ADDENDUM NO. 2 – January 9, 2025

**Valverde Park Renovation – CIP PK 24-04
Mossdale Park Renovation – CIP PK 25-01**

This addendum amends the Contract Drawings and Specifications for this project as follows:

1 REMOTE CONTROL VALVE

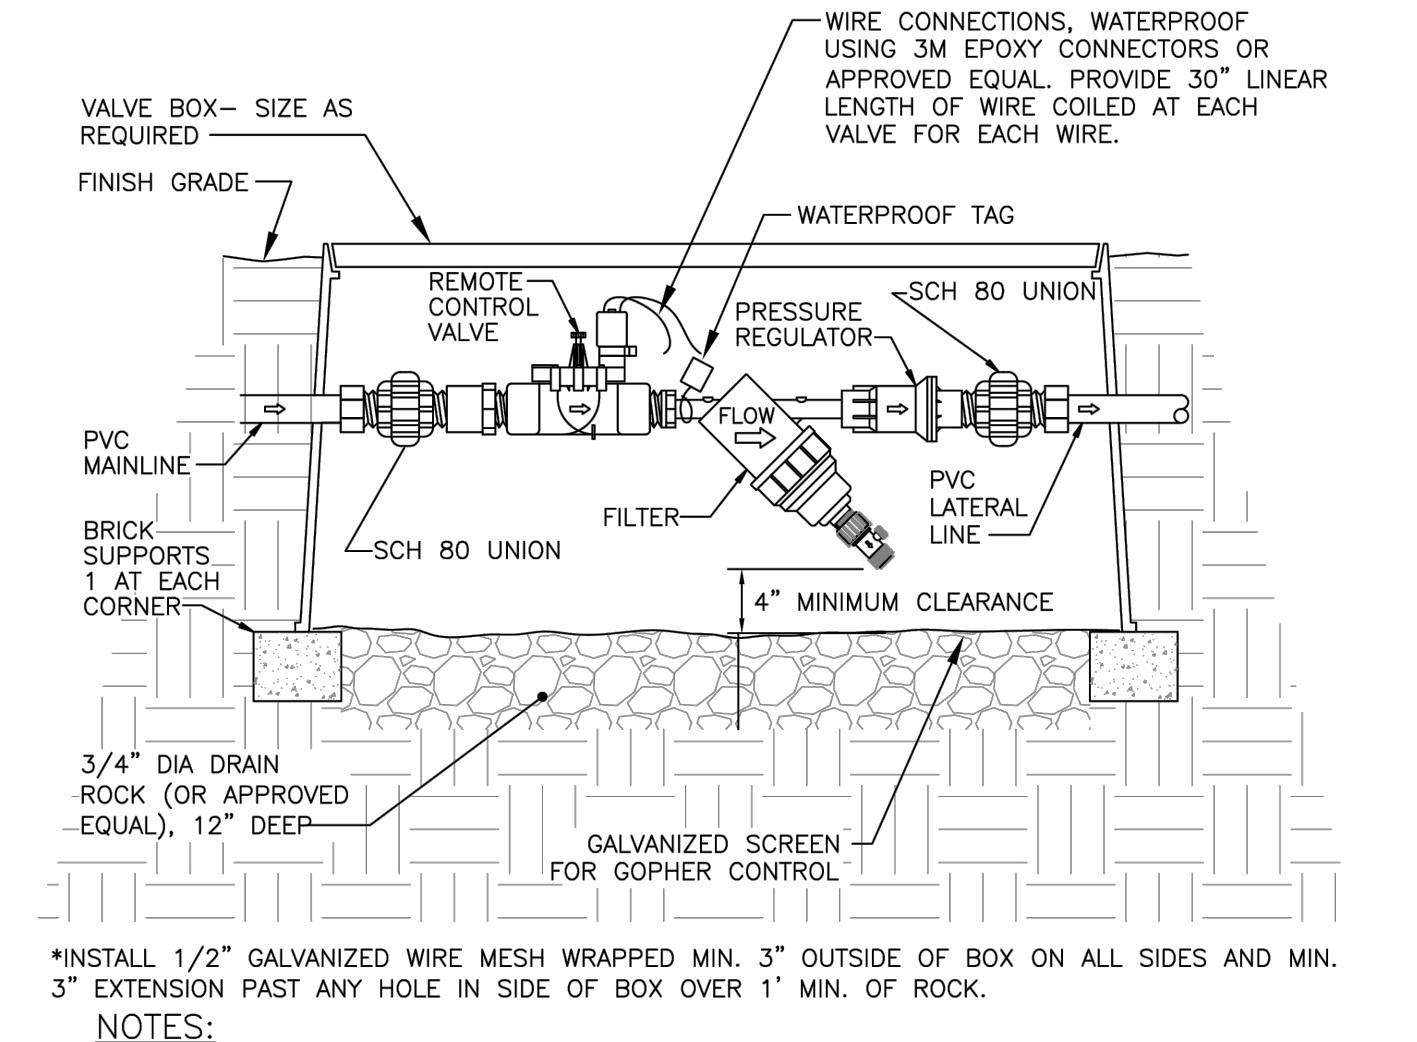
SHEET L6.0– MOSSDALE LANDING PARK – IRRIGATION PLAN (IRRIGATION LEGEND): Description of Remote Control Valve changed to “REMOTE CONTROL VALVE: RAIN BIRD PESB-R INDUSTRIAL REMOTE CONTROL VALVE, GLOBE CONFIGURATION WITH SCRUBBER TECHNOLOGY, SIZE PER PLANS.”

2 Drip Irrigation Control Valve Assembly - City Standard

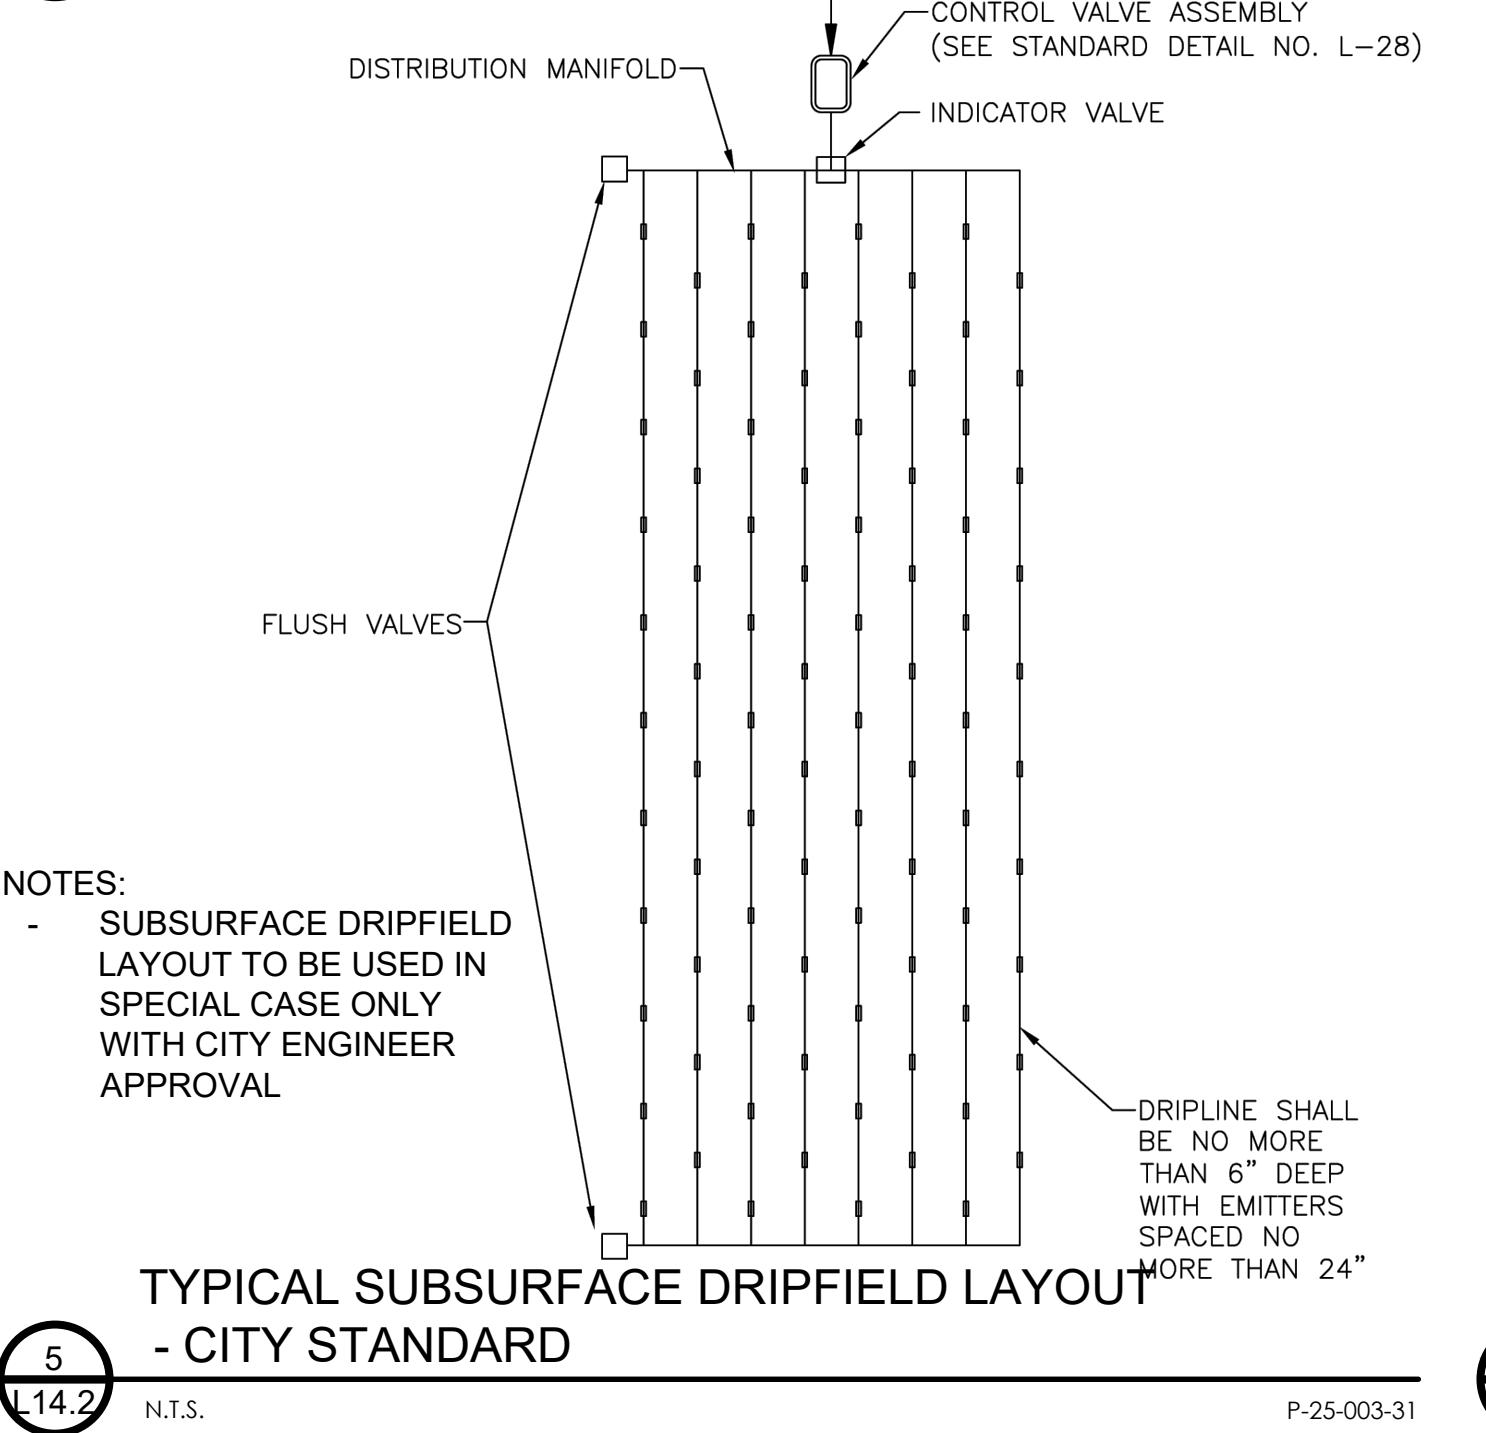
SHEET L6.0– MOSSDALE LANDING PARK – IRRIGATION PLAN (IRRIGATION LEGEND): Symbol for Drip Remote Control Zone Kit updated and description changed to “DRIP REMOTE ZONE CONTROL KIT: RAINBIRD XCZ-150-LCDR”

8 TREE DRIP RING LAYOUT

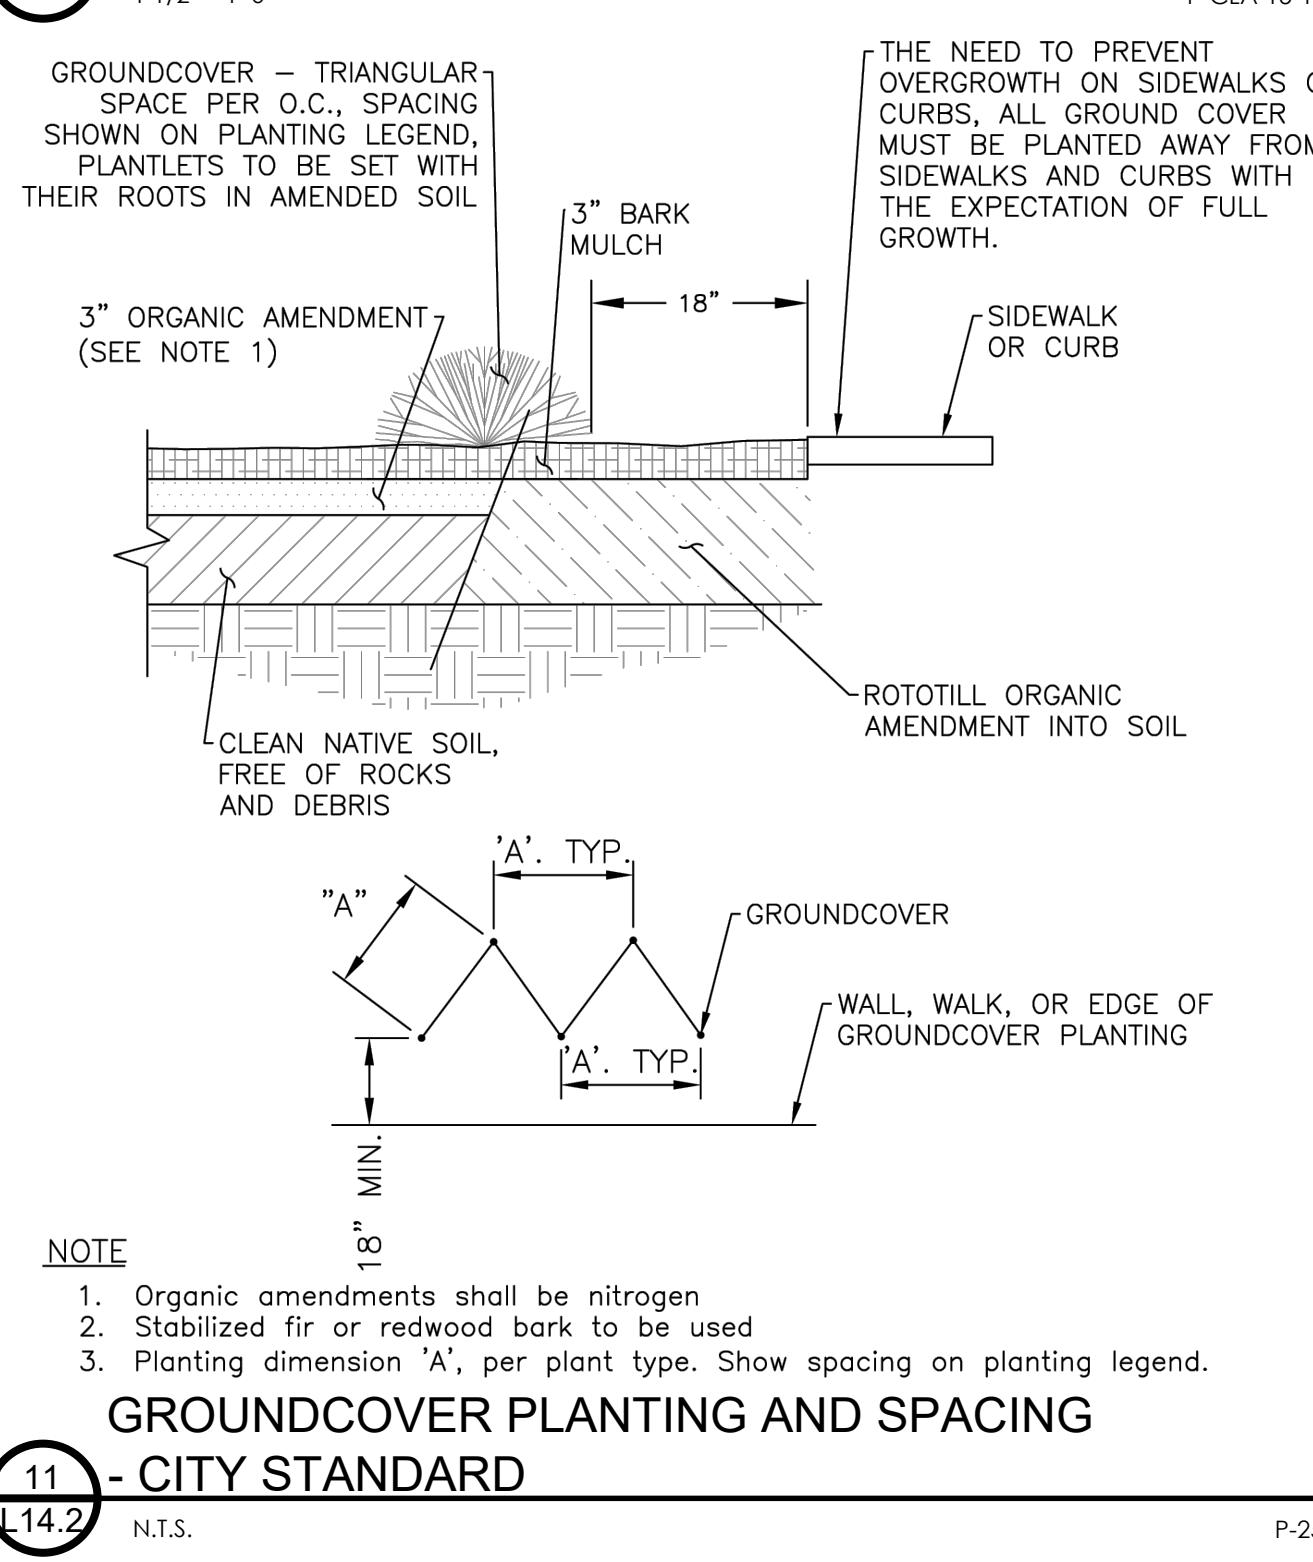
RFI 7: Irrigation detail 5/L4.12 indicates dripline shall be no more than 6" deep. However, detail 12/L14.12 shows that dripline shall be installed above grade. Please clarify.

A7: Dripline for project with the exception of tree drip rings, shall be buried 4"-6" deep. Tree drip rings shall be installed on surface.
